West Parish Filters Water Treatment
Plant
1515 Granville Road
Westfield, MA 01085
Project No. 24-51

ADDENDUM NO. 16 06/18/2024

ADDENDUM NO. 16

DATE:	FEBRUARY 2024
HAZEN NO.:	90398-004
CONTRACT NO.:	24-51
DRAWING NUMBER:	C-245

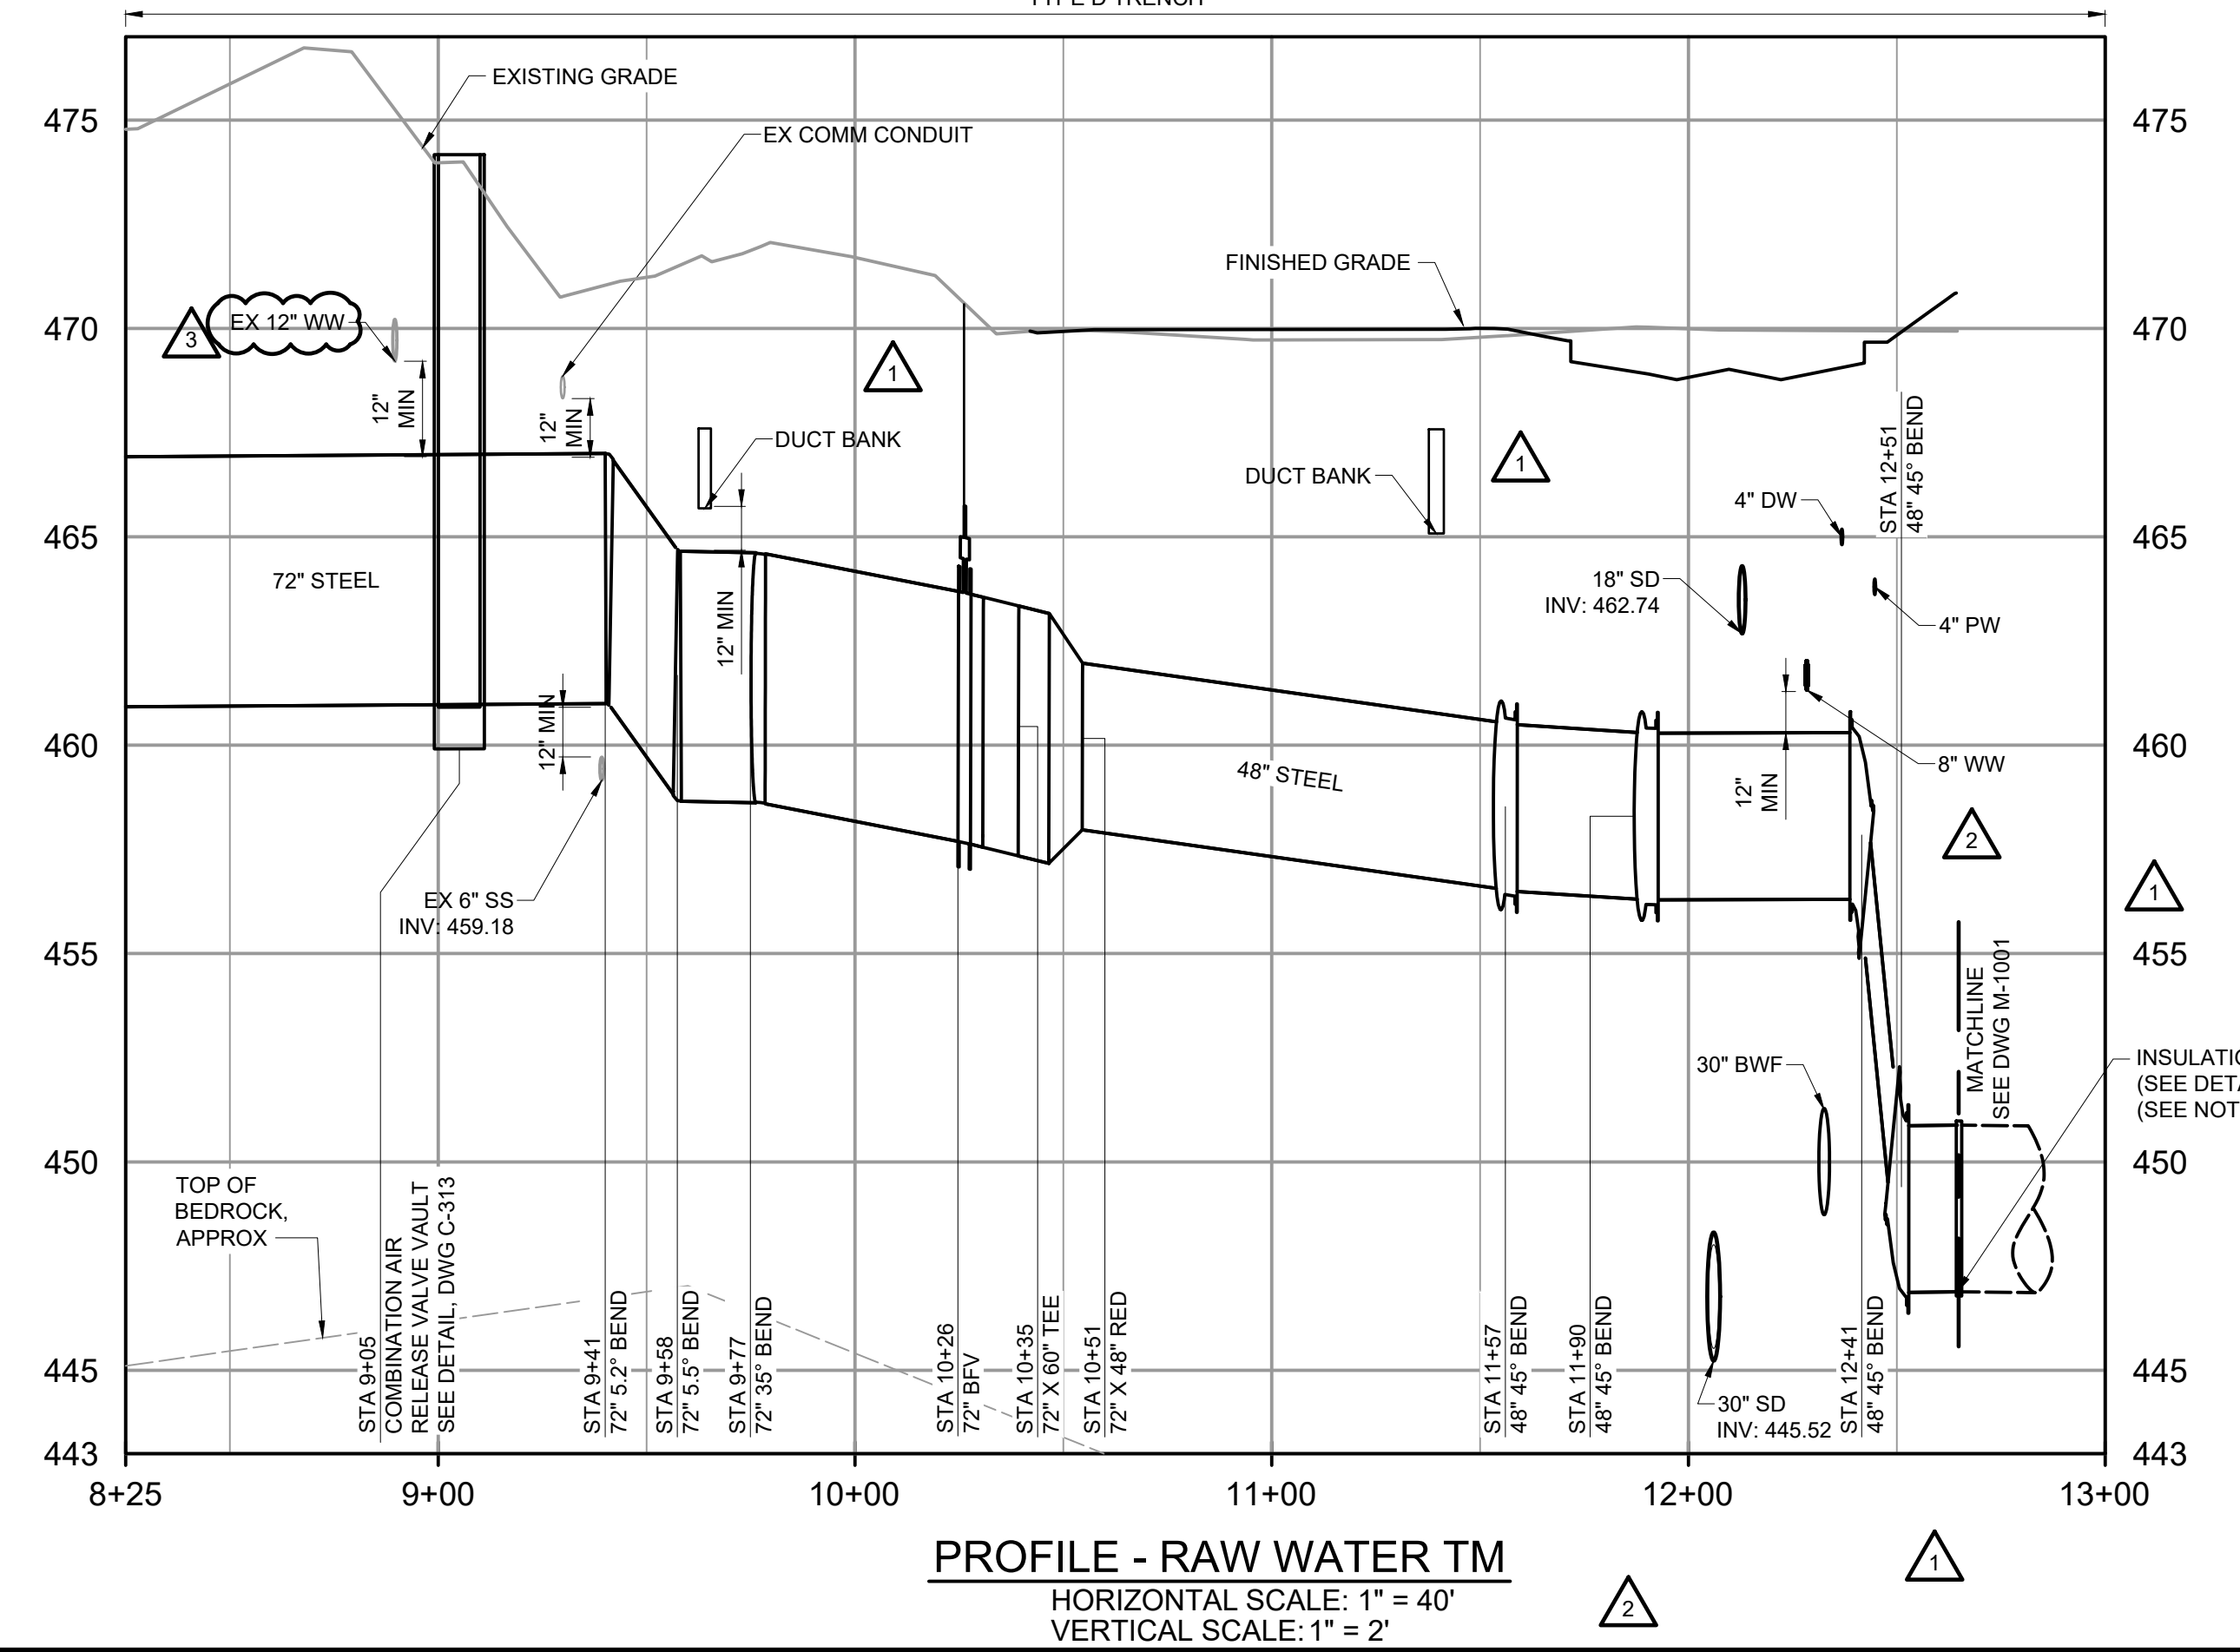
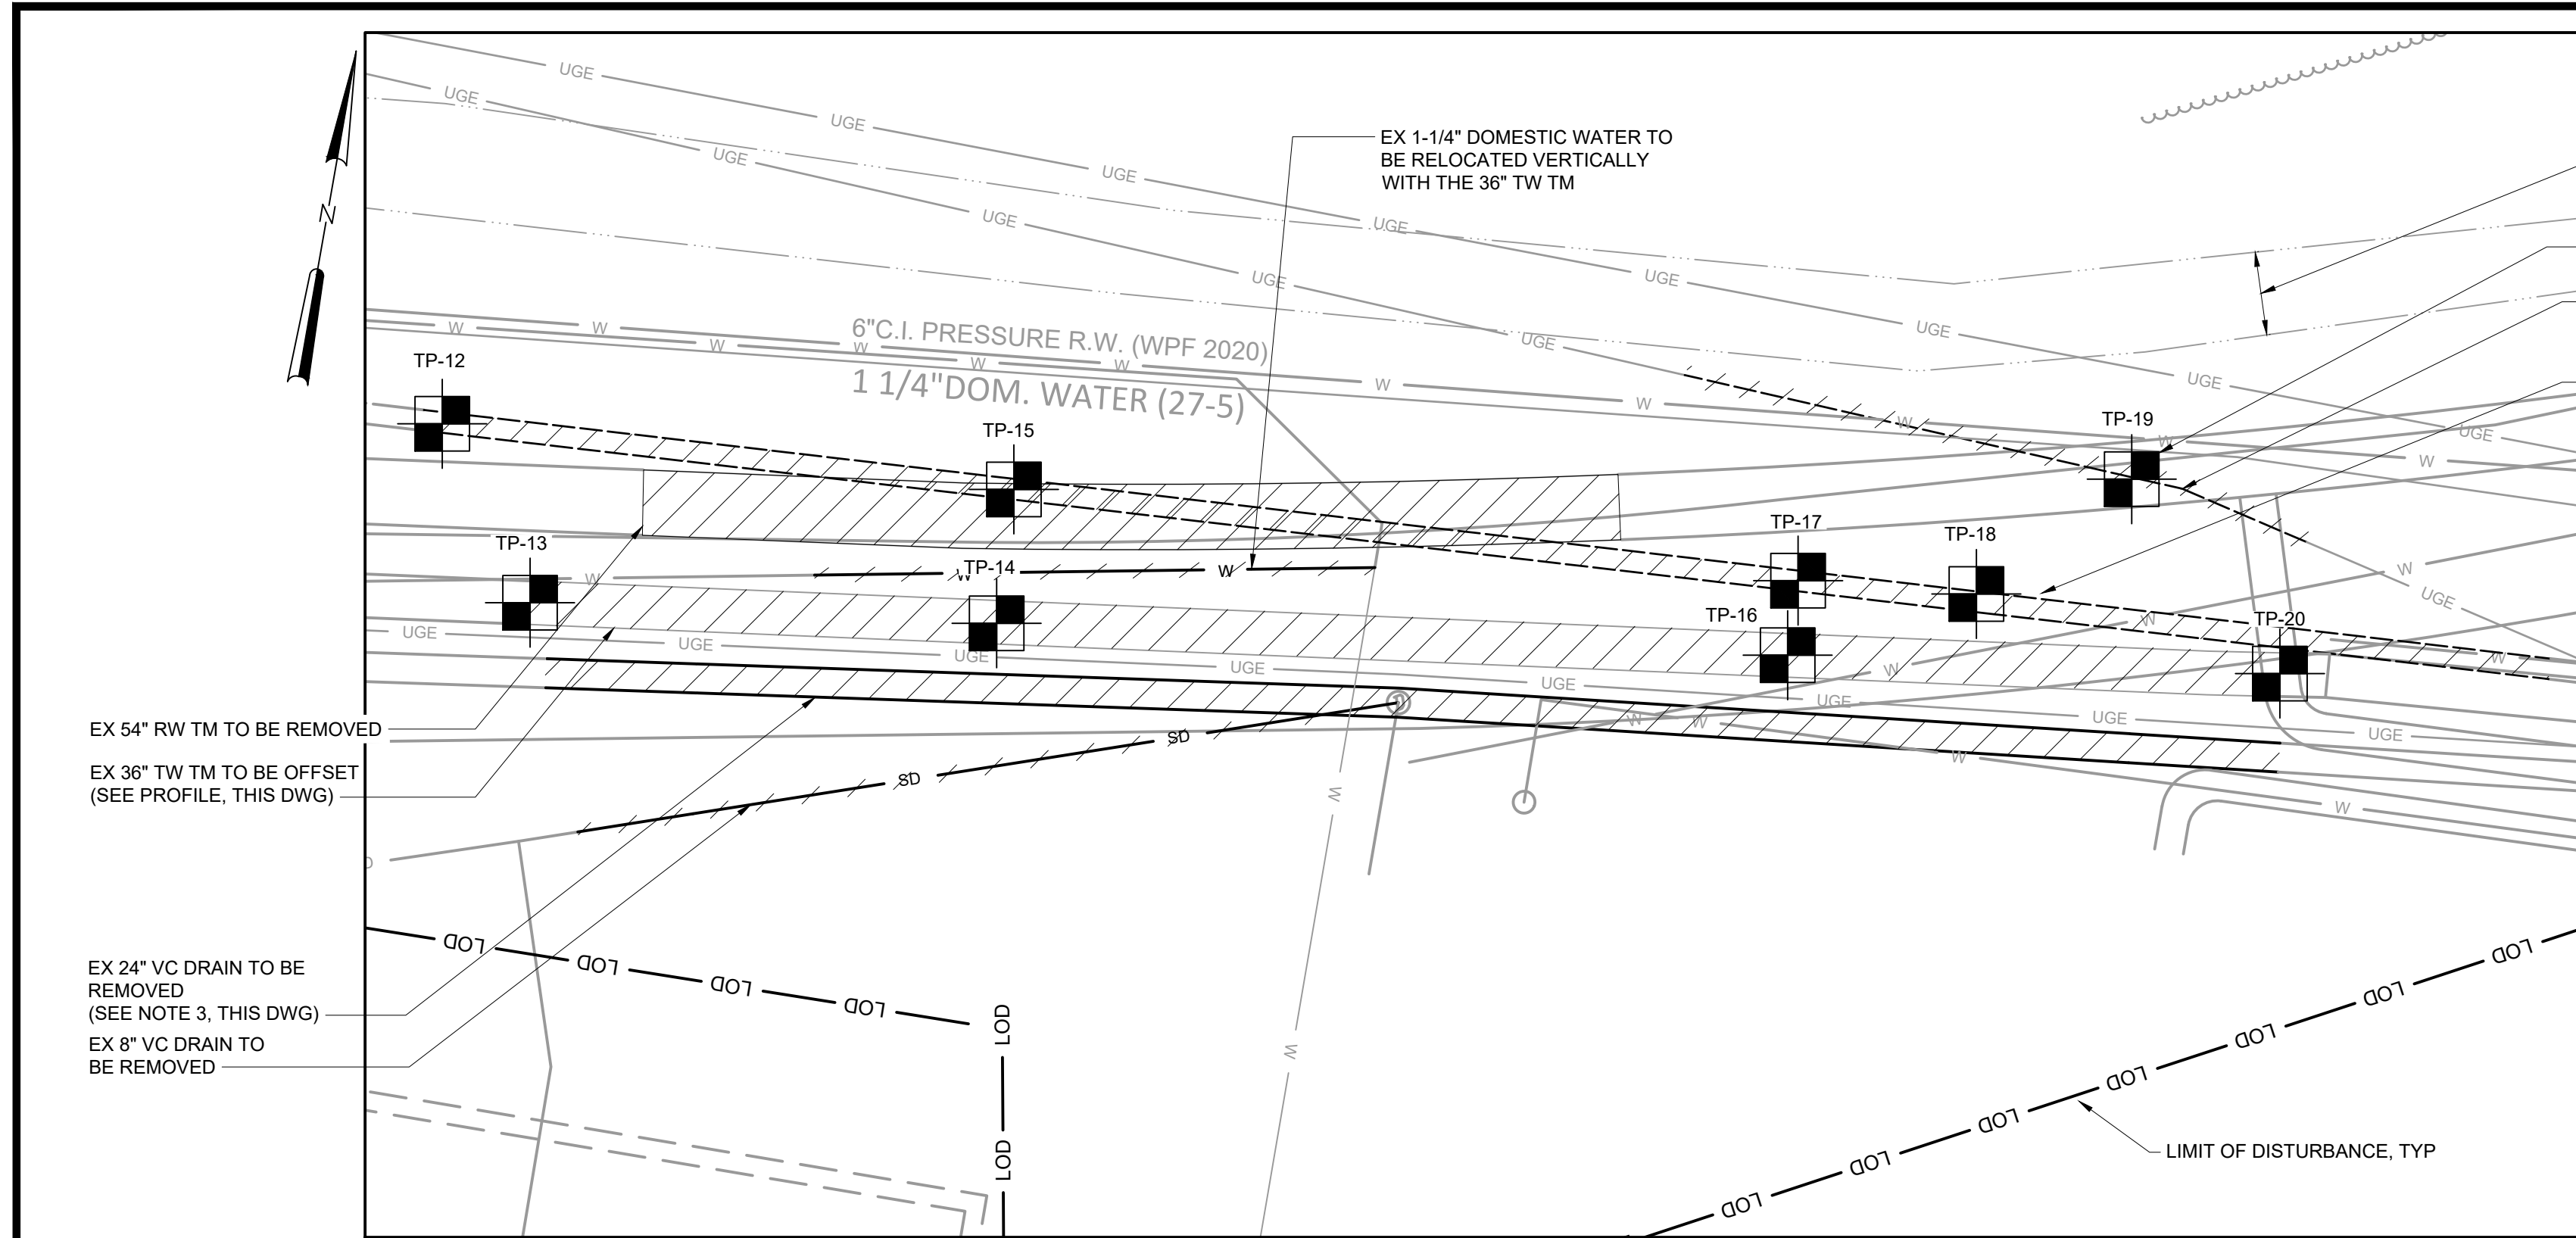
16-Q10	3. Addendum 12, Form of General Bid, page 6, 2nd paragraph – Clarify why the Contractor is paying the premiums for the performance and payment bonds for the Pre-Selected Filed Sub-Bidders?	Language is per the statutory requirements of MGL 149, section 44E.
16-Q11	4. Addendum 12, C-241, C-242, and C-243 plans appear to mislabel the Type B and D trenches as they relate to C-317 trench details. Confirm Type D trench is only required at the concrete encased TM.	The raw water transmission mains shall be encased as indicated on drawing C-241, C-242, and C-243. The encasement is reinforced as detailed on drawing C-311. The reinforced encasement shall be backfilled as indicated on the profile drawings, Type B. The sections of TM that are called out with a Type D trench, shall be backfilled with flowable fill. Note 1 on drawings C-243 and C-245 was revised to match Note 1 on drawings C-241, C-242, C-244.
